GFA AIRWORTHINESS DIRECTIVE

SUBJECT: Elevator and elevator pushrod.

**Airworthiness
Directive
2003-048**

SHEMPP-HIRTH Flugzeugbau GmbH. Kirchheim/Teck	Technical Note No. 360-19	Page No. 01 No. of pages 02								
<u>SUBJECT:</u>	Horizontal tailplane and elevator pushrod									
<u>AFFECTED:</u>	Sailplane Discus-2a and Discus-2b (TC-No. 360) Serial Nos: 13 - 22, 24, 27, 28, 30 - 48, 50, 51, 53 - 55, 57 - 63, 65, 67, 68, 71 - 79, 81 and 82 <u>Important remark:</u> <u>Not</u> affected are sailplanes which comply with Technical Note No. 360-16 !									
<u>URGENCY:</u>	At the occasion of the next annual inspection, but not later than April 30, 2003.									
<u>REASON:</u>	To improve the flutter stability a mass balance on the elevators in connection with a lighter elevator pushrod in the vertical fin have to be installed.									
<u>ACTIONS:</u>	<div>1. <u>Elevators</u> A mass balance must be added to the elevators according the working instructions that the hinge moments are within the tolerances of the datas on page 2.2.1, issue December 2002, of the Maintenance Manual.</div> <div>2. <u>Elevator pushrod</u> An elevator pushrod (drawing No HS8-31.005) according the working inst

WORKING INSTRUCTIONS FOR INSTALLING ELEVATOR MASS BALANCE

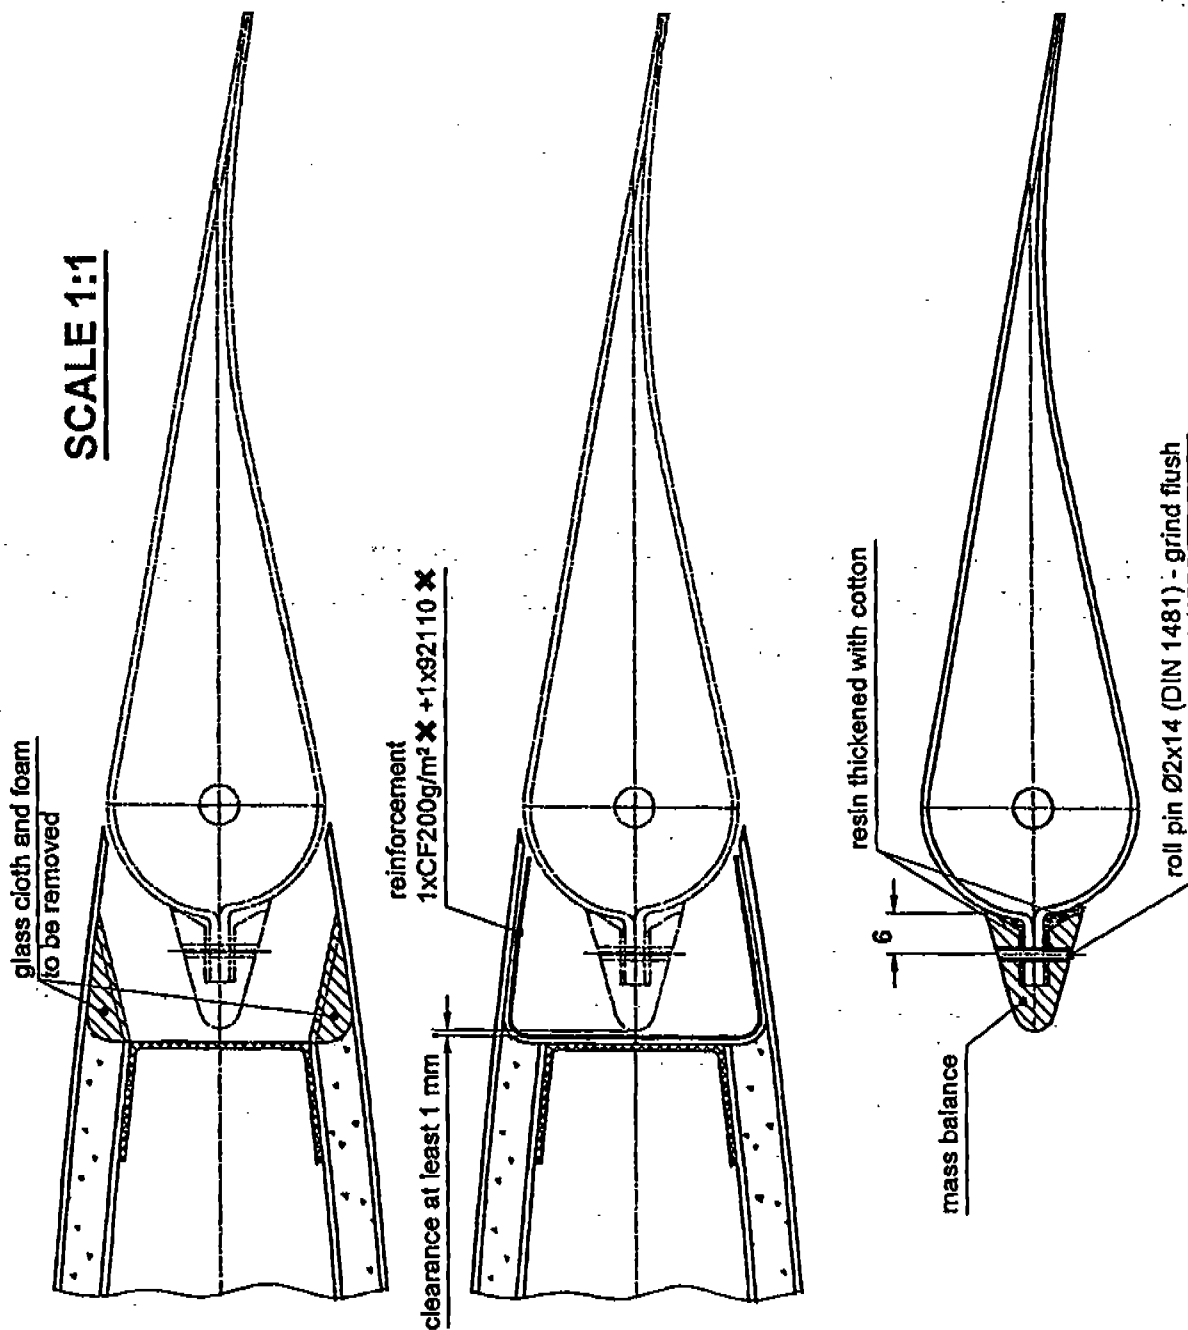
1. Remove sealing tape prior dismounting the elevator halves.
2. Stabilizer
 - a) Remove glass cloth and foam core from shroud up to the web
- see also page 02 and 03.

- b) Reinforce shroud and web by applying additional carbon/glass cloth layers – see page 03.
3. Mass balance
 - a) Fit mass balance weight to elevator halves; make sure that there is a clearance of at least 1 mm between lead and web – see page 03.
If necessary, shorten elevator joining flange ahead of the hinge or grind off mass balance at the leading edge..

- b) Bond mass balance weight in place and install roll pins.
 - c) Check elevator for free travel and determine residual moment (revised values shown in the Maintenance Manual).
If required, fit and install further mass balance (inwards) as described above – for gaining more space follow step 2.) if necessary.

- d) Check once more elevator for sufficient travel – if necessary, grind off balancing lead.
 - e) Determine residual moment and mass of elevator halves.

4. Reinstall elevator halves.
5. Check elevator for free travel and proper deflections within the permitted range.
6. Install again the sealing tapes.

Working instructions for removing/reinstalling the vertical elevator actuating rod inside the fin

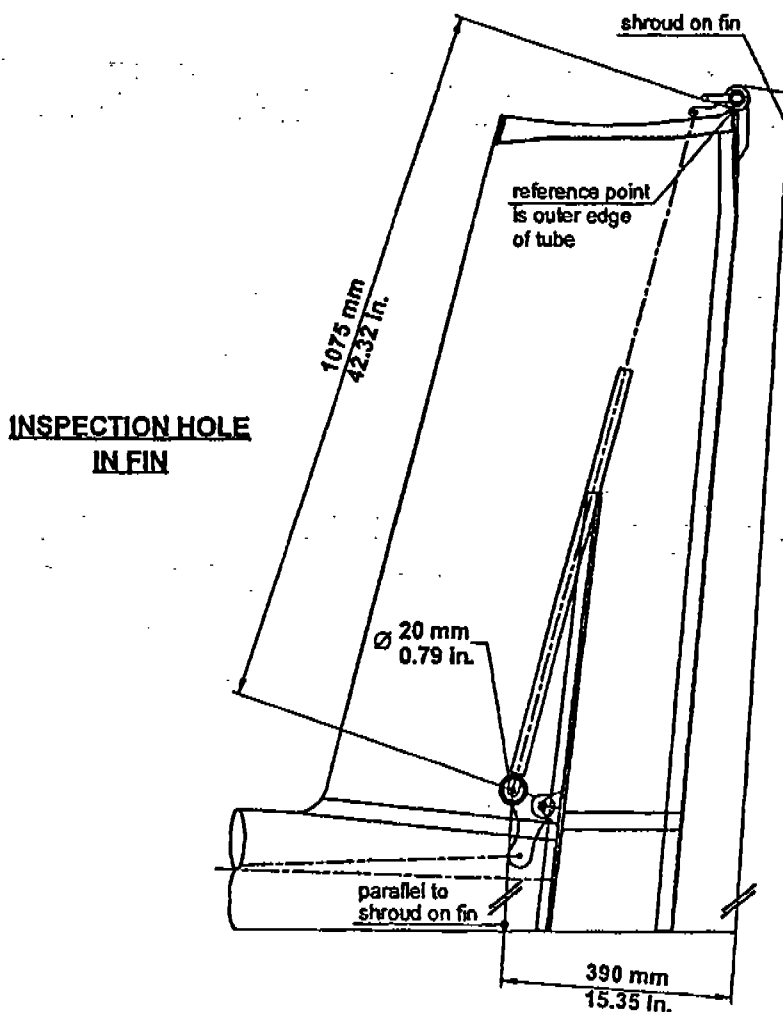
- a) Remove bolt „M6“ connecting the vertical elevator actuating rod to the bellcrank (at base of fin) using a socket wrench (10 mm).

Recommendation: Thin tape in the socket of the wrench will prevent nut and bolt from falling down into the fuselage tail cone. The washer is removed with the aid of a small magnet. Using a drift facilitates the removal of the connecting bolt.

- b) Disconnect upper end of vertical elevator actuating rod from elevator actuating bracket (at top of fin) and remove rod.

- c) Reinstall new elevator actuating rod.

- d) Check elevator deflections – if necessary, readjust ball bearing rod end.

Make sure that thread of rod end has entered for a depth of at least 10 mm (0.39 in.)

- f) Check tail cone for foreign objects and tape over the openings at the base of the fin.

ZZ - tape position and sealing

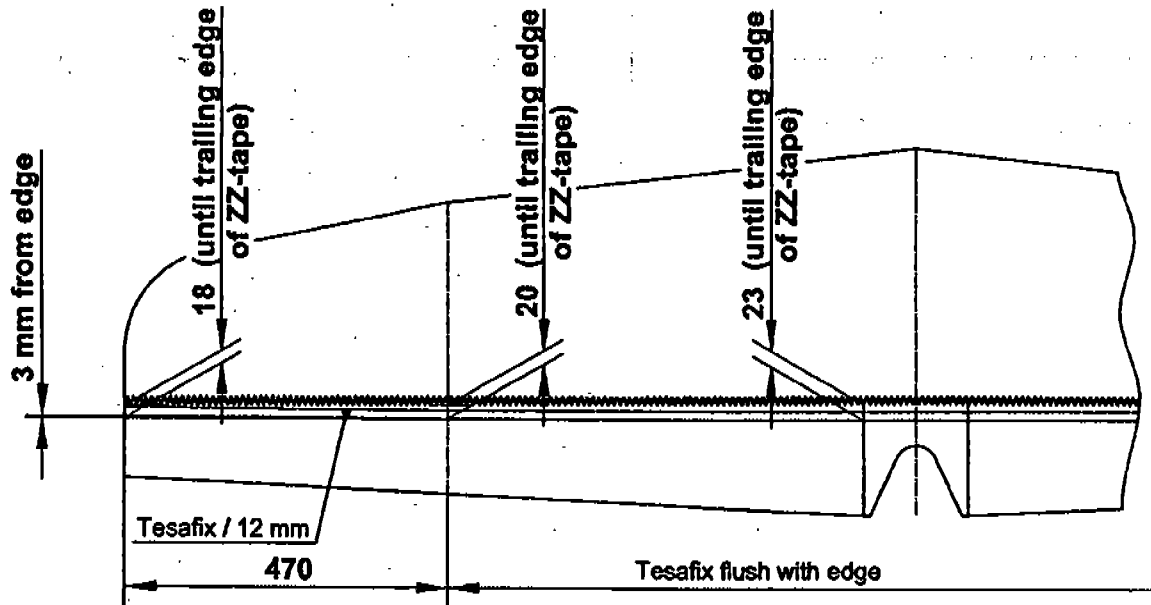
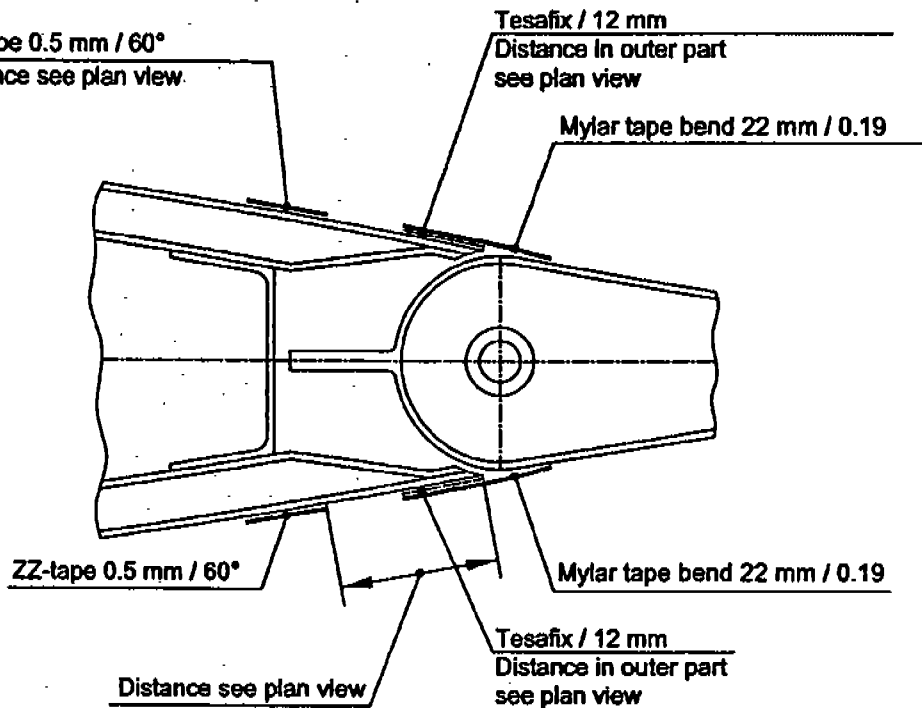
ZZ-tape 0.5 mm / 60°
Distance see plan view.
